APPLICATION FOR PERMISSION UNDER SECTION 16 OF THE TOWN PLANNING ORDINANCE

Section 16 Planning Application for

Planning Statement August 2024

Section 16 Planning Application for Proposed Minor Relaxation of Building Height Restrictions for Permitted Public Housing Development at Tung Chung Area 114 and Area 117, Lantau Island

Figure 4 – Expected Wind Flow Pattern under Annual Prevailing E (Top), ESE (Middle) and SE Wind (Bottom)

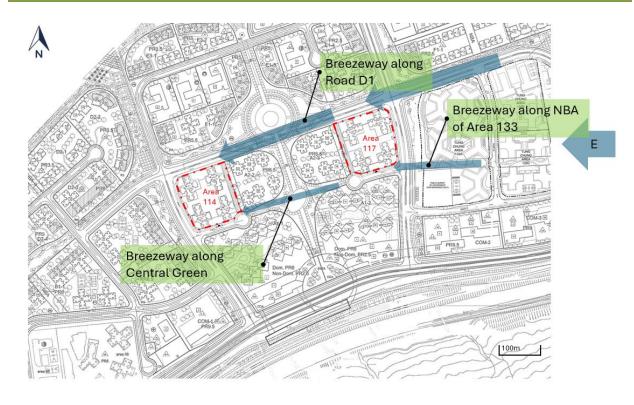
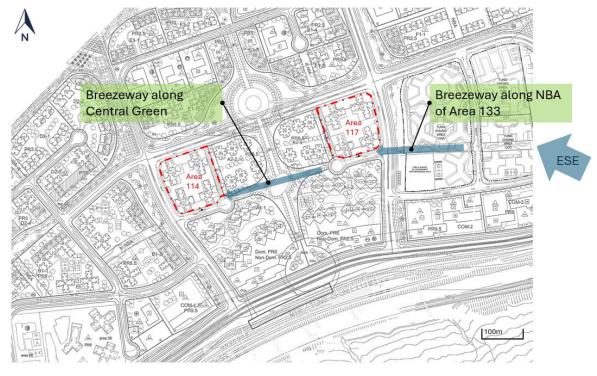
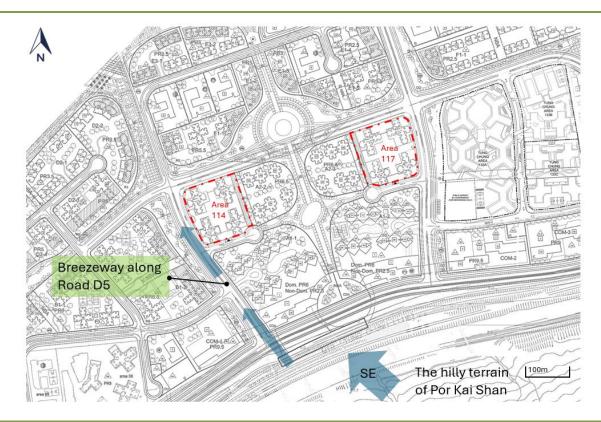
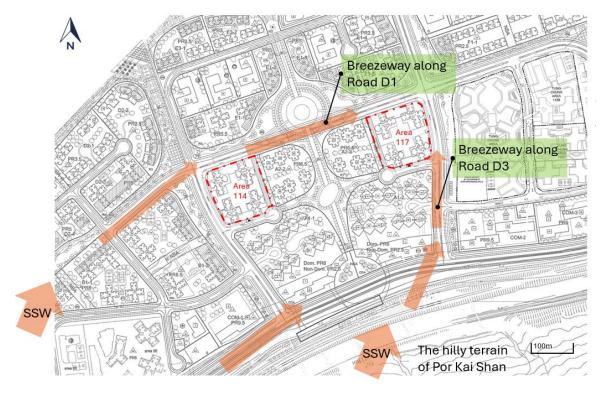
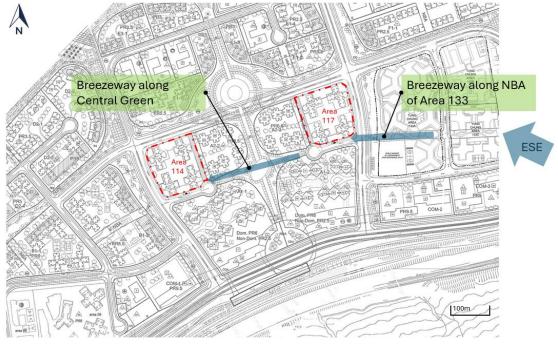
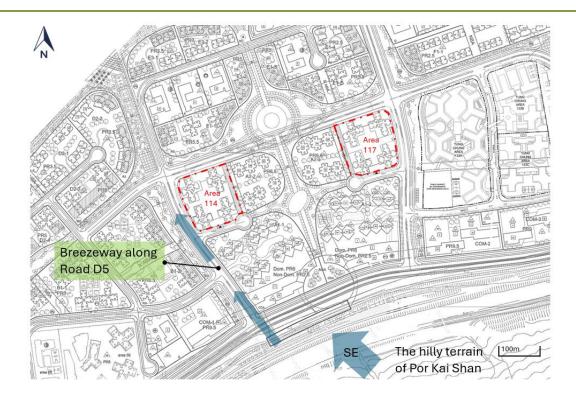
4.7.	Section 3.1.3 – Similar to the above comment, consultant please consider updating the text and remove the breezeway along Road D1 in Figure 5.	The text describing wind patterns under ESE and SE wind is revised as described in the above response to comment. The breezeway along Road D1 is removed in Figure 5 for ESE wind. Meanwhile, a breezeway along Road D5 is added in Figure 4 and Figure 5 for SE wind.

4.8.	 (i) Consultant please use the building blocks of the proposed scheme of both Sites in Figures 4 and 5. (ii) Noting the Consultant considered the approved s.16 application no. A/I-TCE-4 as mentioned in Section 3.3, please update the block layout in Figures 4 and 5. Furthermore, in the wind flow pattern, Consultant may consider to reflect the impact of the approved applications. 	The building block of the proposed scheme is included in Figure 4 and Figure 5. The building block of Area 133 are adopted from approved s.16 application no. A/I-TCE-4 and included in Figure 4 and Figure 5.

Figure 6 – Master Layout Plan of Baseline Scheme (left) and Proposed Scheme (right) of Area 114

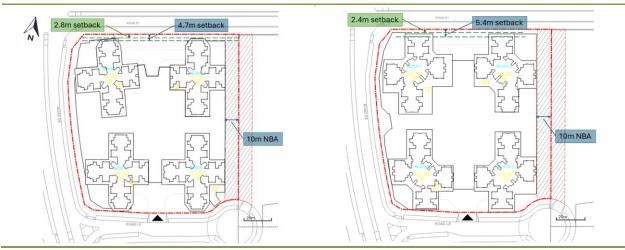
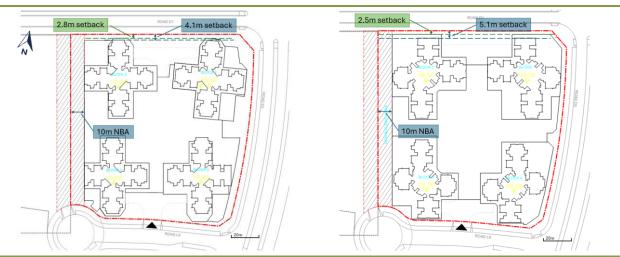
4.13	Section 1.2.2 – Should read as "Table 21 and Table 2".	Typo of Table number is amended.
4.14	Figures 6 and 7 – "Base Scheme" should read as "Baseline Scheme".	"Baseline Scheme" is used consistently throughout the revised AVA appraisal.
